ADDENDUM NO. 1 ELEMENTARY ADDITION TO SUMTER CENTRAL HIGH SCHOOL

Architect Job No. 24-38 July 24, 2024 DCM # 20240619

PROJECT:	PROJECT NO.	REFERENCE:
ELEMENTARY ADDITION TO SUMTER CENTRAL HIGH SCHOOL	24-38	ADDENDUM NO. 1
ARCHITECTURAL ADDENDUM DRAWING	DATE:	SHEET NO.
ANCHITECTORAL ADDENDOW DRAWING	7/10/2024	ADD 1

SHEET TITLE: ELECTRICAL GENERATOR DETAILS

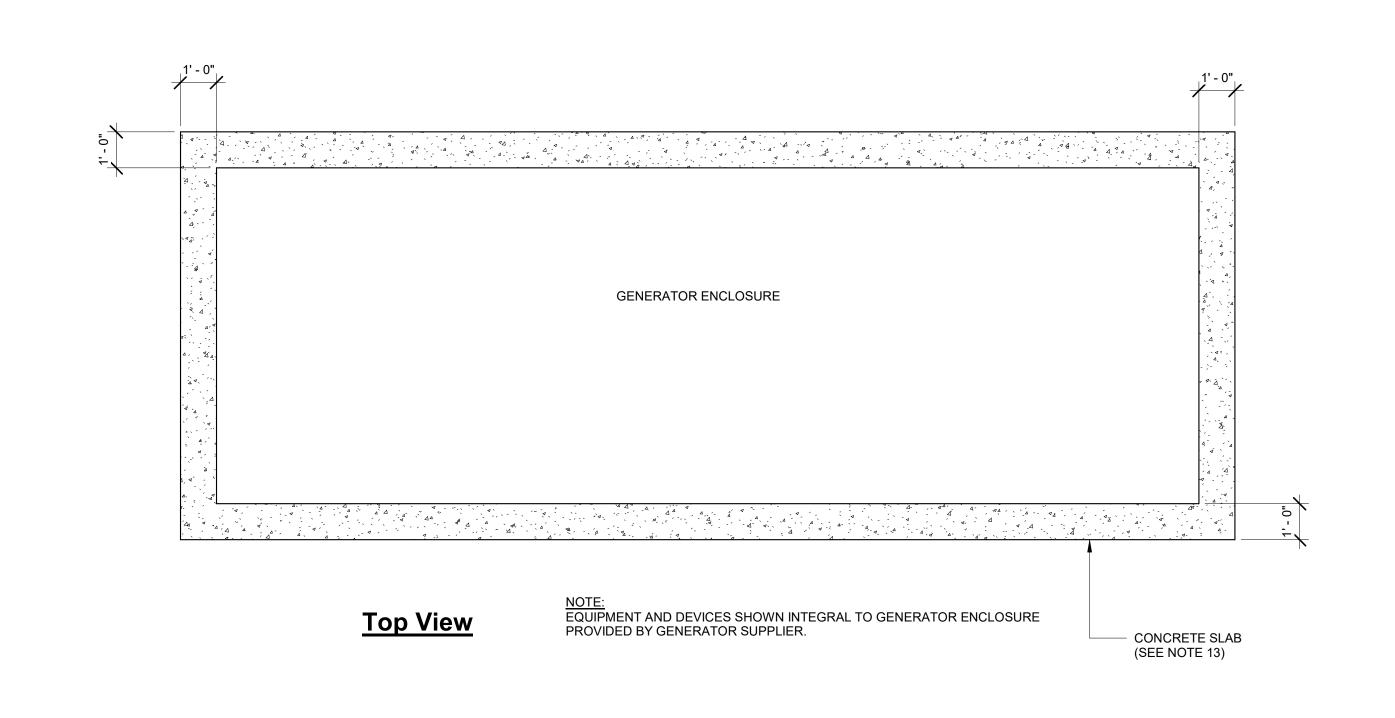
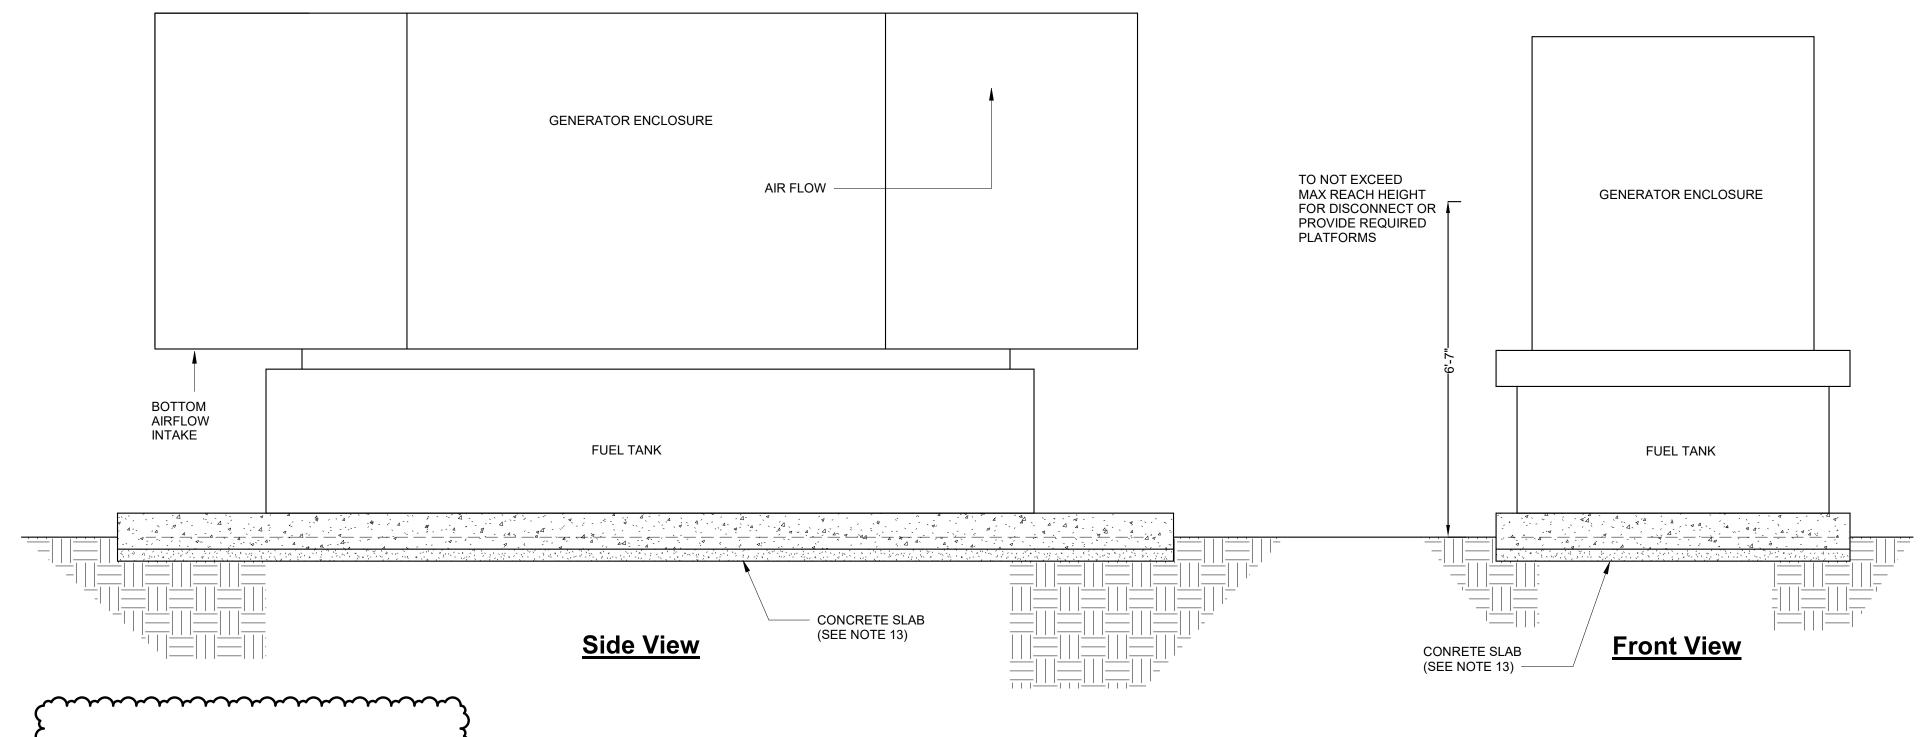
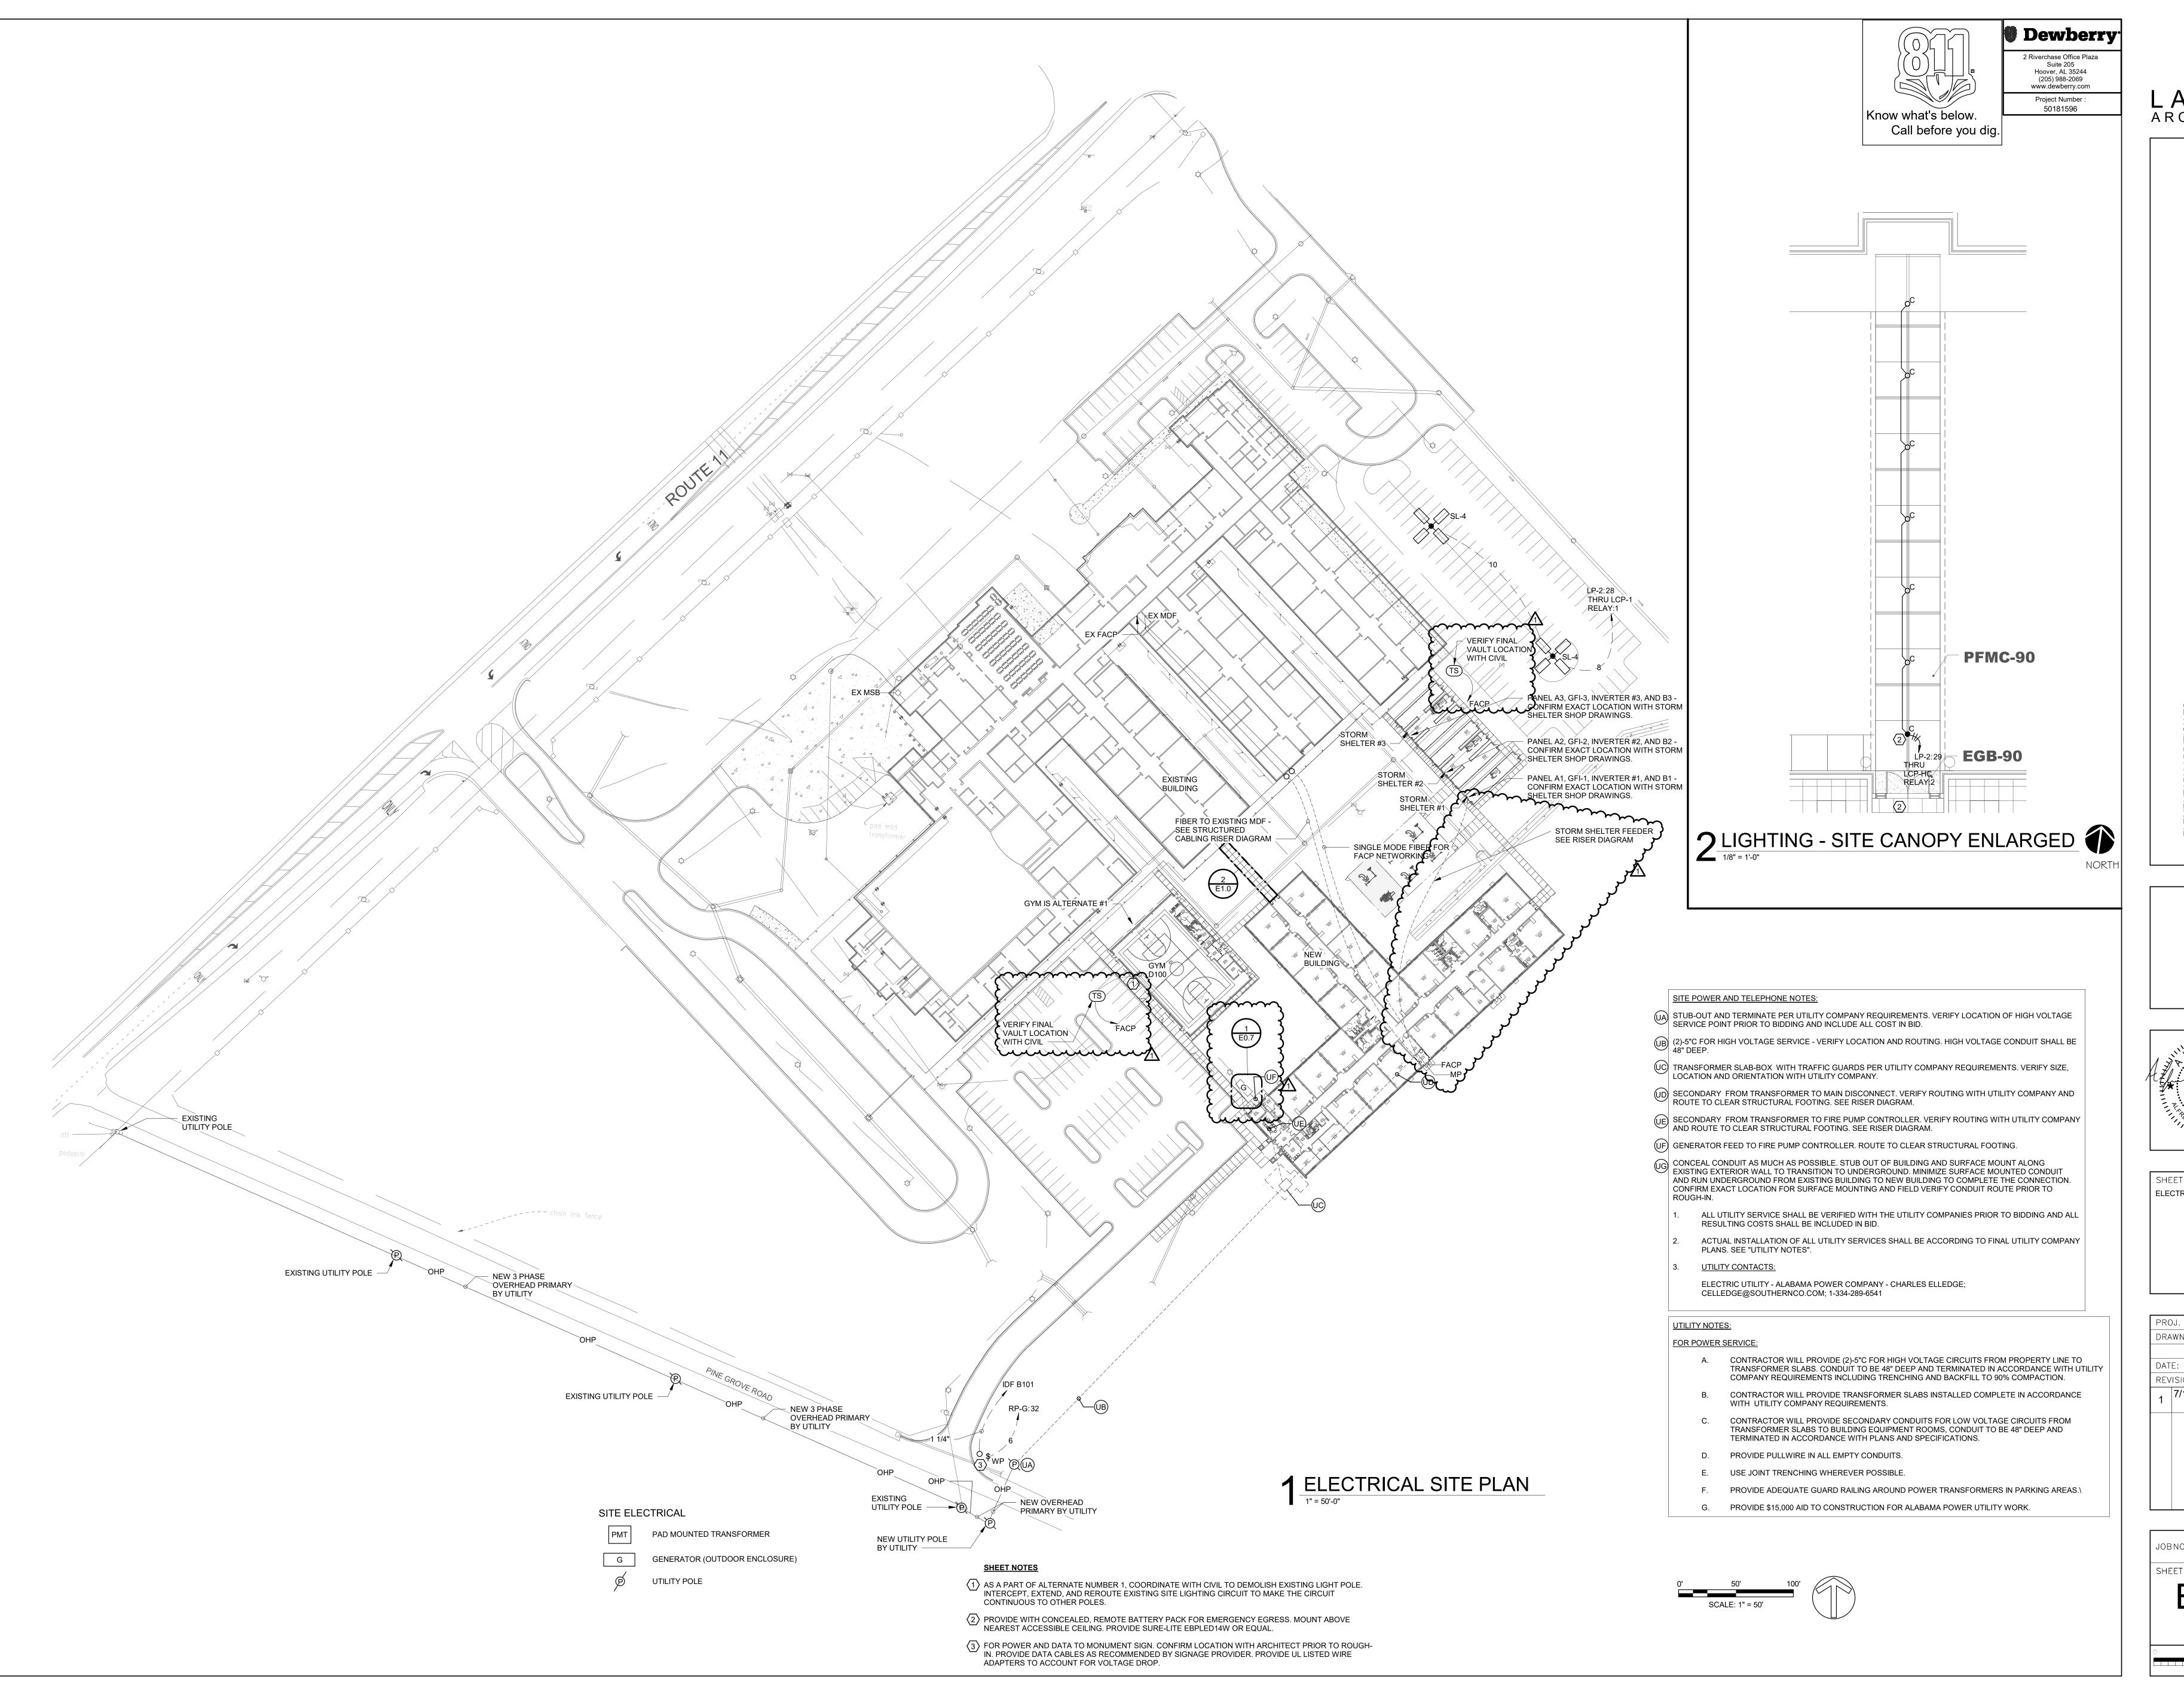
- 30. See attached Sheet **E0.7** for revised Electrical Generator Details.
- 31. See attached **E1.0** revised to include underground feeder route to storm shelter and to include tamper switches.

<u>LIGHTING - FLOOR PLAN - PART A</u>

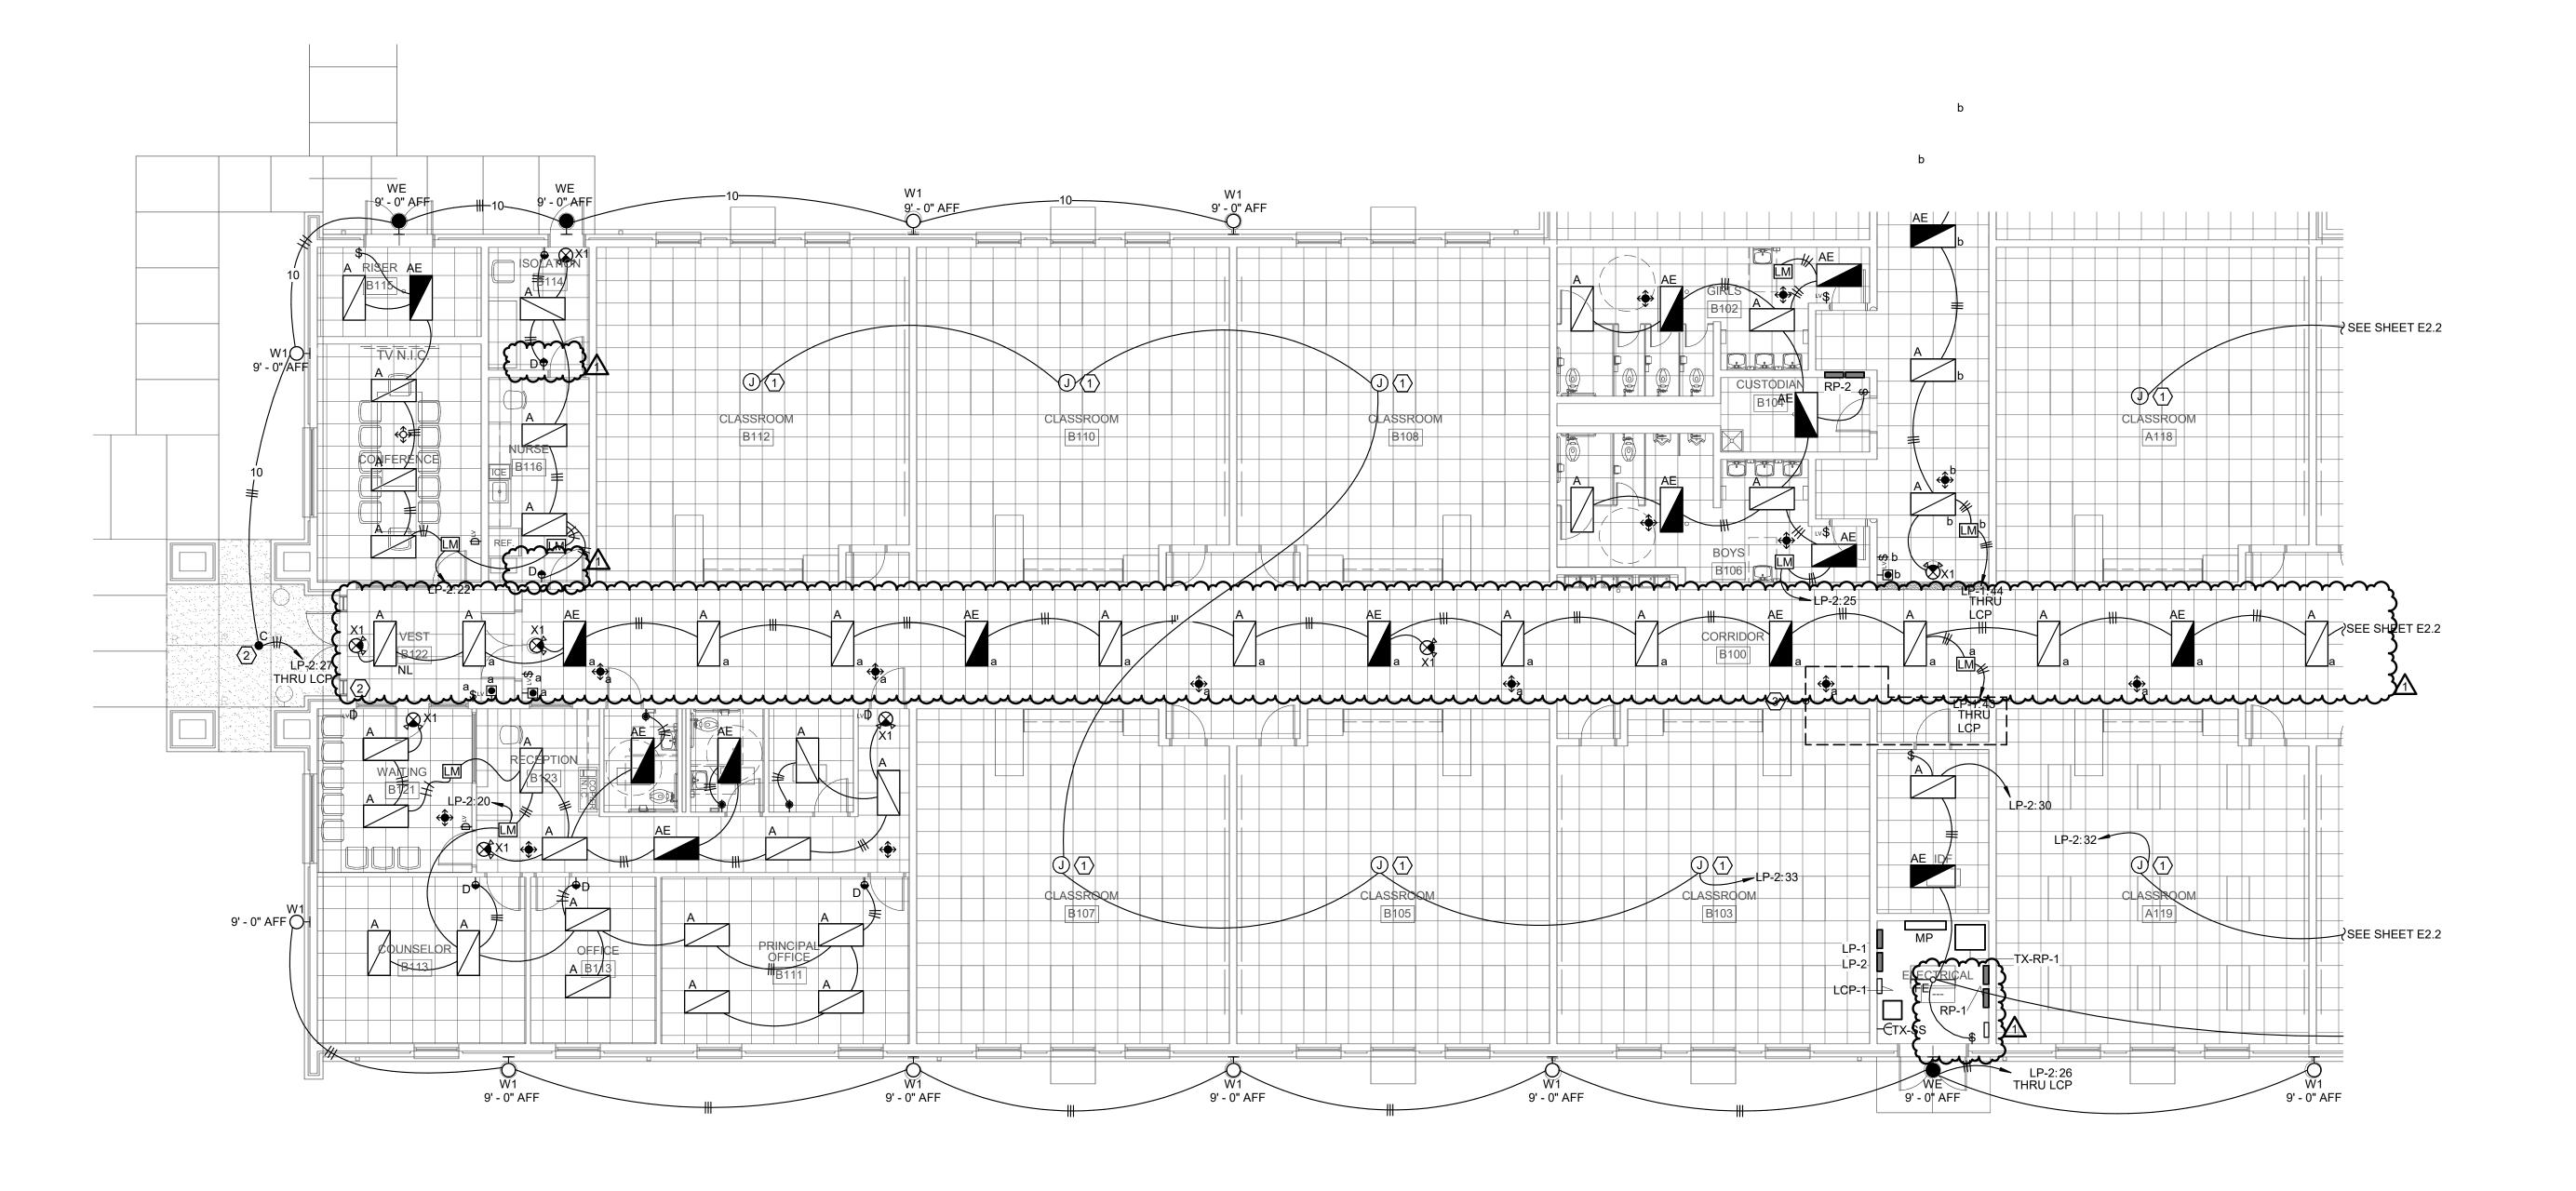
- 32. See attached **E2.0** revised to provide continuous dimming in addition to full ON and Full OFF.
- 33. See attached **E2.1** for Storage D103 to have vacancy wall switch "Manual on".
